**Service Update  
Second Half — 2011**

**Prepared by: WHIRLPOOL CONSUMER CARE**

**PART NO. W10446215**

### Gas Smell in Upper Oven

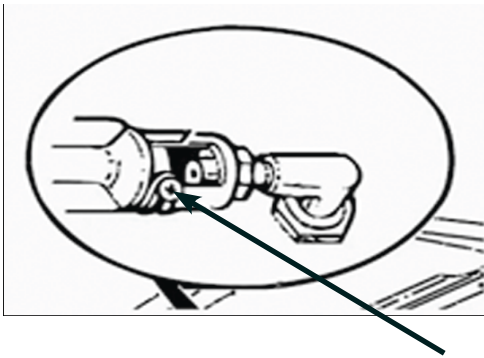
**Concern:** Gas smell from upper oven during a bake cycle.

**Cause:** Cross-over flame on upper oven bake burner is getting too much primary air, preventing ignition, and allowing unburned gas to escape into oven. Altitude, barometric pressure, gas composition, or consistency of the cross over porting may have an effect.

**Solution:** Close the air shutter on the upper oven bake burner to the mechanical stop creating a longer, slightly lazy flame that allows crossover for ignition. New burner orifice part # W10342662 (.055 versus .054) will also be made available to provide a better distribution of gas and air.

**Loosen Adjustment Screw and close Air Shutter**

Door Hinge  
Mounting Screw

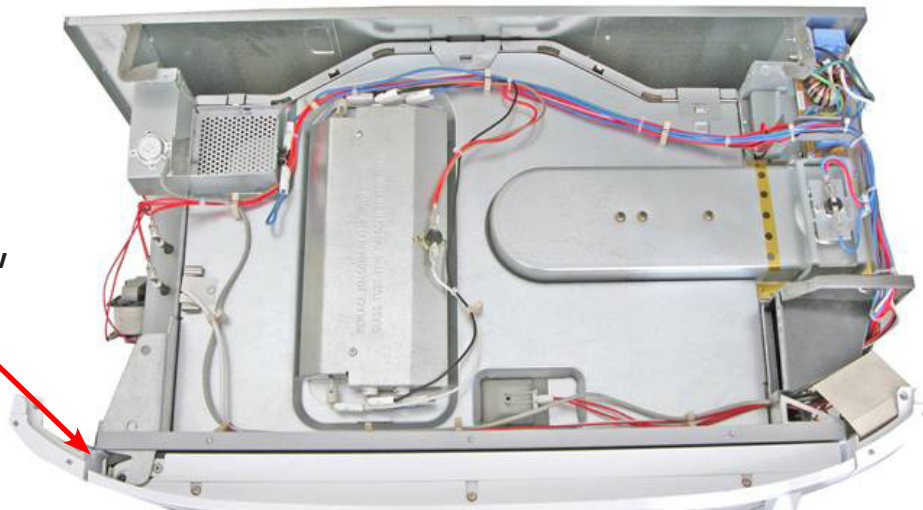
**Concern:** Removing oven door difficult because hinge mounting screw are stripping out.

**Cause:** Manufacturing is using a locking sealant on the screw that makes it difficult to remove. Hinge is welded in place, so removing it is not possible.

**Solution:** Use a soldering gun to heat the sealant before attempting to remove the screw.

Figure 1

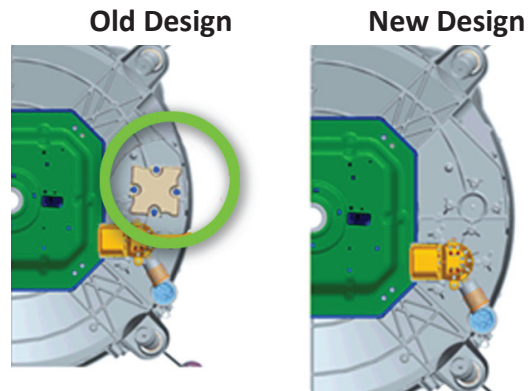
The counter balance weight is being eliminated, see figure 1.

Figure 2

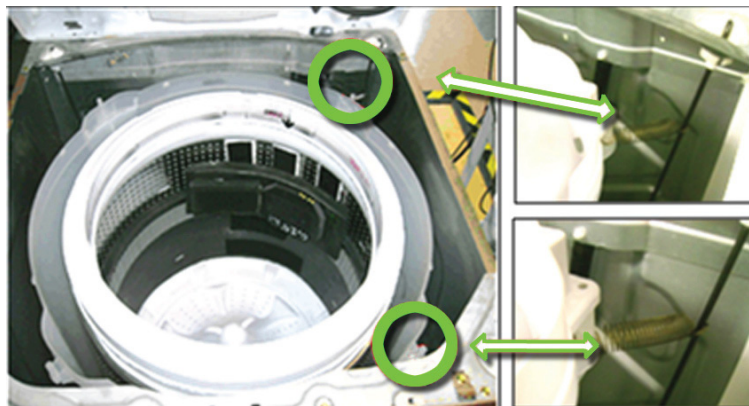
Two small tub centering springs that secure to the upper tub bosses on the right side and suspension rods have been added, see figure 2.

Figure 1

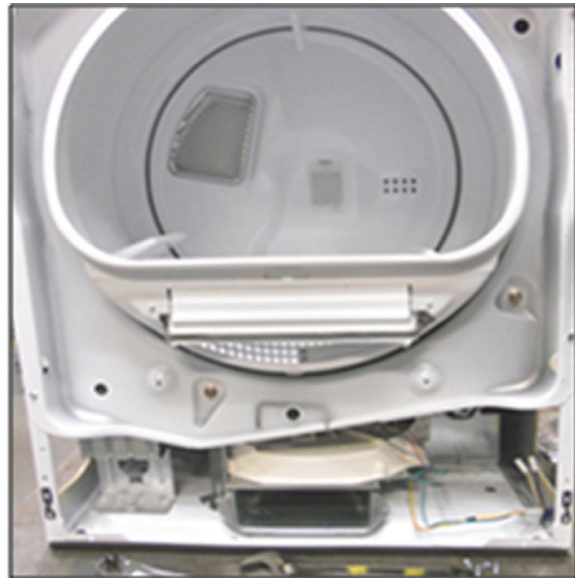
Blower pulley comes loose from blower shaft.

The pulley may not have been tightened properly.

1. a.) Unplug dryer or disconnect the power. Remove front panel and lint chute, see figure 1.
- b.) Remove the blower pulley (Figure 2), completely from the bearing shaft (if not already disengaged).

Figure 1

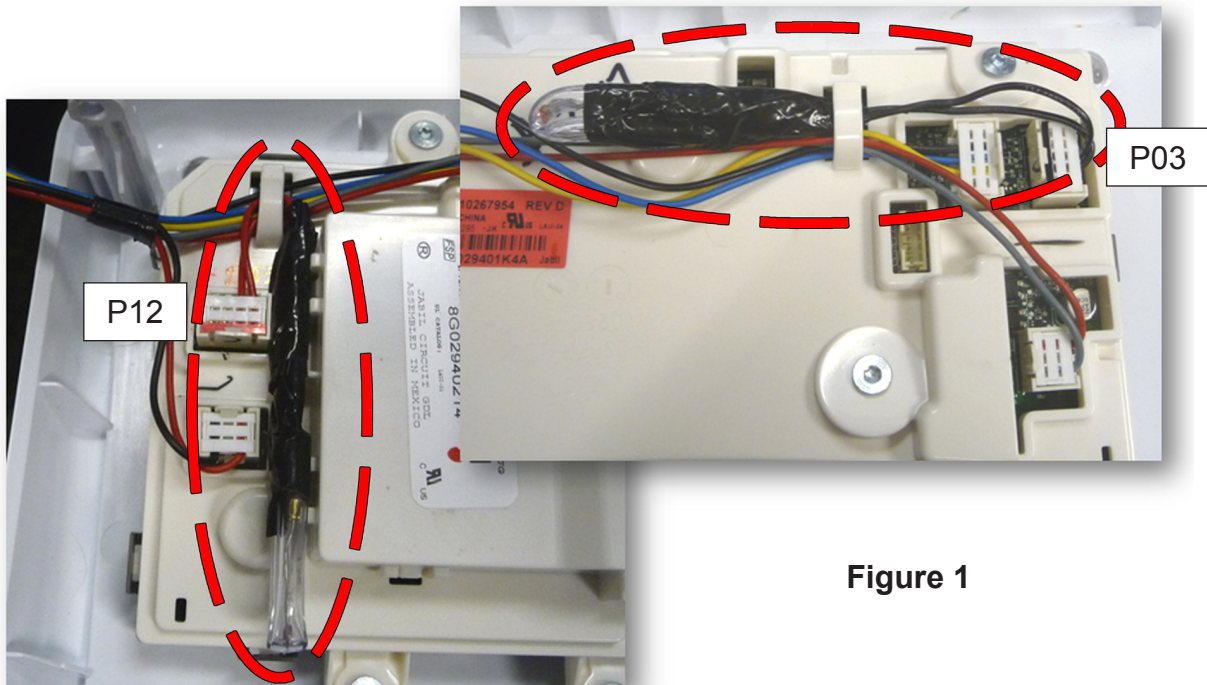
The User Interface (UI) is unable to communicate to the Cycle Control Unit (CCU); although, the CCU can communicate to the UI.

Add the 4-pin connector assembly to P12.

Add the 5-pin connector assembly to P03.

Route the resistor assemblies through the guides as illustrated in figure 1.

**Skywalker Power Pin  
Peninsula Slots (P4)**

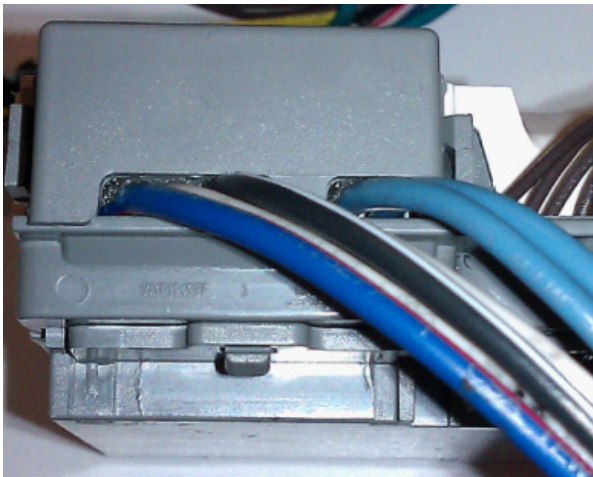
Implemented on all Skywalker controls similar to what was done on the Yoda controls. The peninsula slots open like an “arc tracking fuse” to stop arc tracking activity on the board instead of relying on the traditional TCO. Testing shows that the power trace or peninsula burns open very consistently and reliably when tracking occurs at the power connector, or when it originates in the power & relay circuits above/around the power connector. With the power pin on the peninsula, the peninsula burns open, and separates the incoming power pin from the rest of the PC board. The benefit of this design is that it eliminates the nuisance tripping associated with bimetals and TCO's. These peninsula slots should “only” open when the board has been arc tracking and burned a hole in the peninsula.

**Figure 1 – ProDry™ w/Fan Assist**

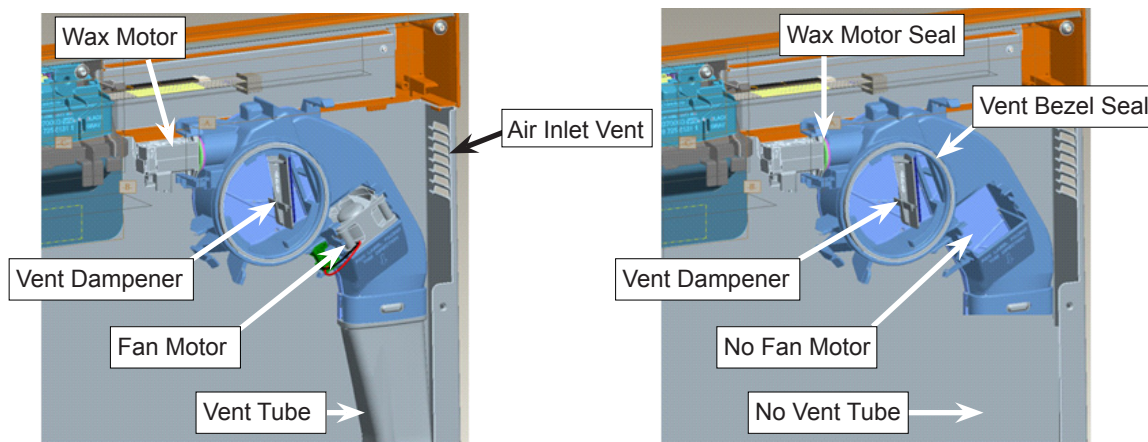
There are two vent designs used, fan assist and non fan assist. See figure 1 & 2. Both venting designs act similar with the exception of the dry cycle.

If you experience moisture between the inner and outer door panels, or on cabinets around the air inlet area of the outer door panel—located near the top left side of the panel (see figure 1), verify that vent damper is closing by using the service diagnostic routine. The procedure is located in the product tech sheet.

Verify that wax motor seal and vent bezel seal are not pinched or missing (see figure 2). Verify there are no leaks around the vent bezel seal allowing moisture past the bezel and into the door panel area. Verify that vent fan motor is operating by using the service diagnostic routine. The procedure is located in the product tech sheet.

**New and Old Stripper Blade**

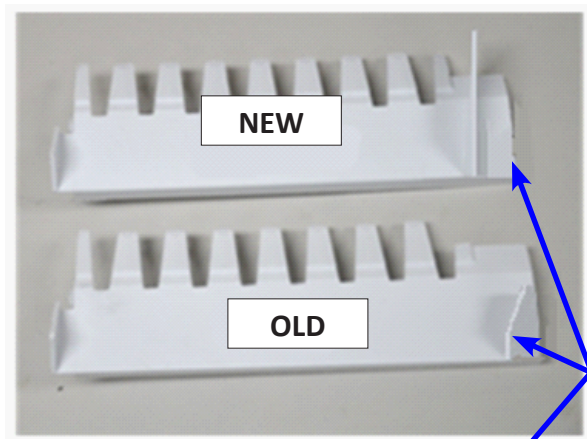
**Concern:**

Current Design  
**W10272869 Large Cube**  
**W10272870 Small Cube**

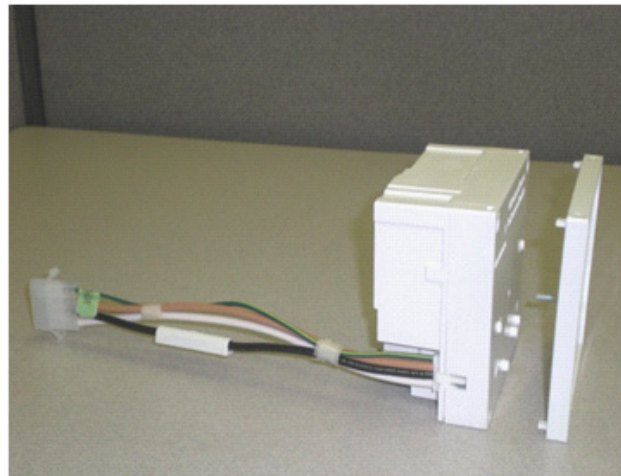
The current In-Door-Ice maker module is being replaced with a new design ice maker. The new ice maker will directly replace the current model.

- Open contacts to sealed switches to reduce the chance of contamination.
- A stronger 1-piece gear replaces the 2-piece snap together gear assembly
- More reliable Molex connector replaces the current Edge card connector

New Design  
**W10377197 Large Cube**  
**W10377153 Small Cube**
